## April 24, 2025 PROJECT NAME: MELODY PRESERVE PROJECT NUMBER: 2024100025 APPLICATION: PRELIMINARY PLAT #32350

# DEVELOPMENT REVIEW COMMITTEE WAIVER REQUEST FORM

C005

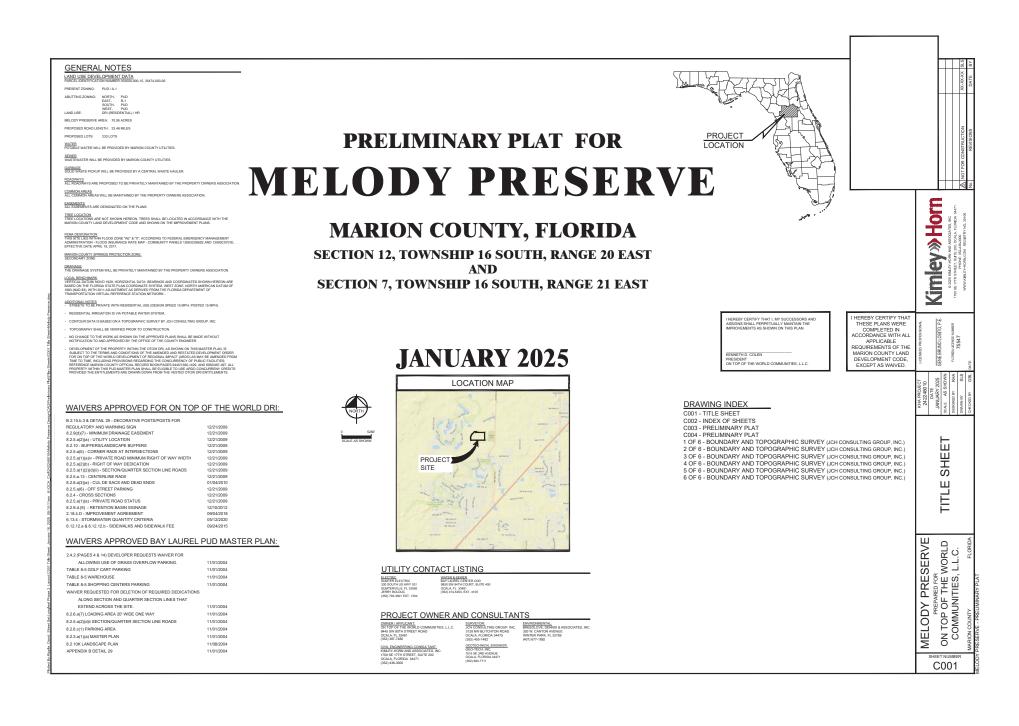
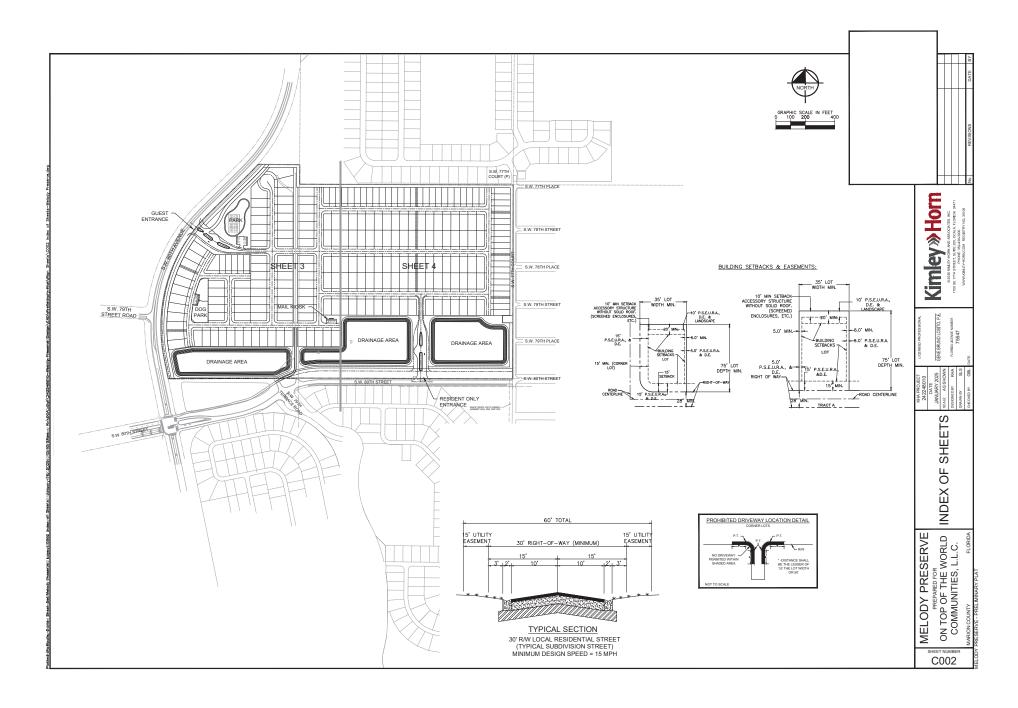
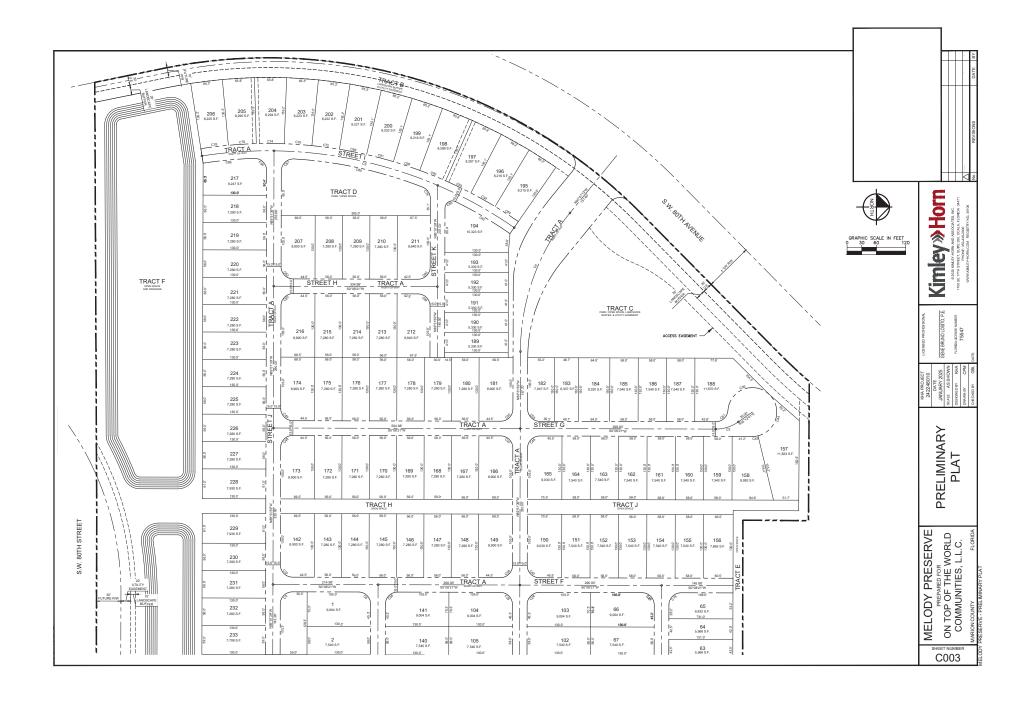
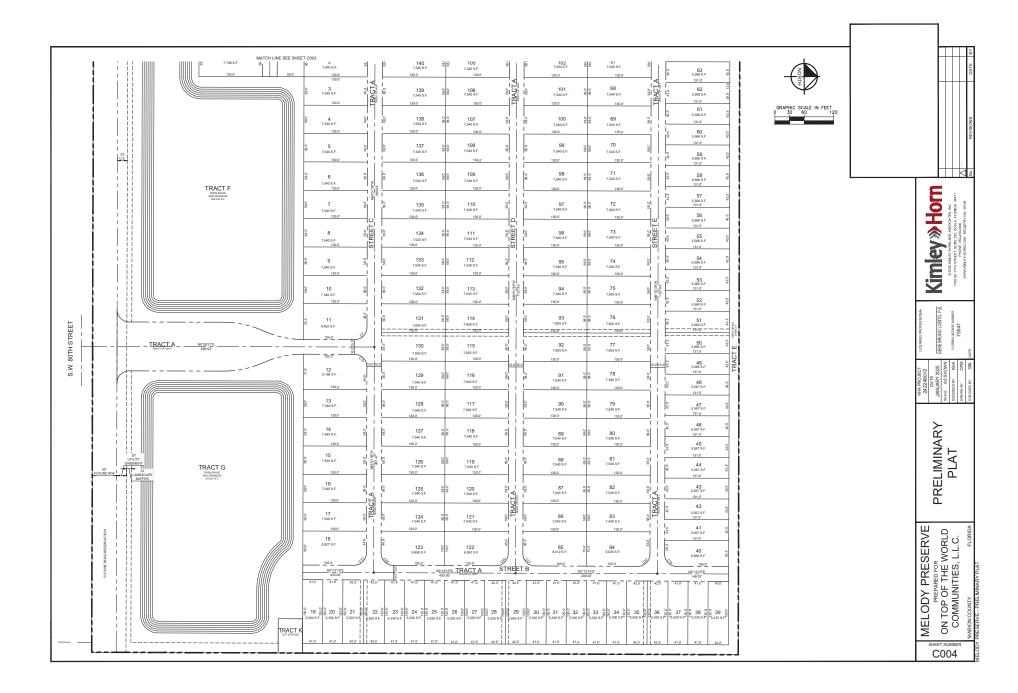
- 29 DEPARTMENT: ENGTRF TRAFFIC REVIEW REVIEW ITEM: 6.12.12 - Sidewalks STATUS OF REVIEW: NO REMARKS: 2/6/25 - 1) Sidewalks are required along one side of internal streets unless otherwise stated by PUD. 2) Provide a multi-use path along SW 80th St., connecting to existing location east of development site and extending to SW 77th Court unless otherwise stated by approved PUD.

Section & Title of Code (be specific):	6.12.12 - Sidewalks
Reason/Justification for Request (be specific):	Request to waive the requirement for sidewalks along one side of internal streets consistent with other age-restricted
communities within On Top of the World. Multi-modal path is being provided to con	nnecting this neighborhood to the extensive multi-modal trail system within On Top of the World.
